Product Information Notification

Product Group: SIL/Friday September 25, 2026/PIN-SIL-083-2026-REV-0

Revision in SQJ142EP Datasheet from Rev. B to Rev. C

Capacitance

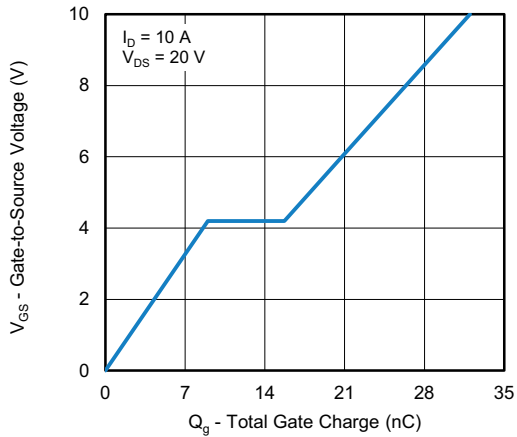
- Update Crss typ from 30pF to 53pF and Crss max from 42pF to 75pF
- Update capacitance graph
- Correct typo on Qgd typ from 6.7nC to 6nC
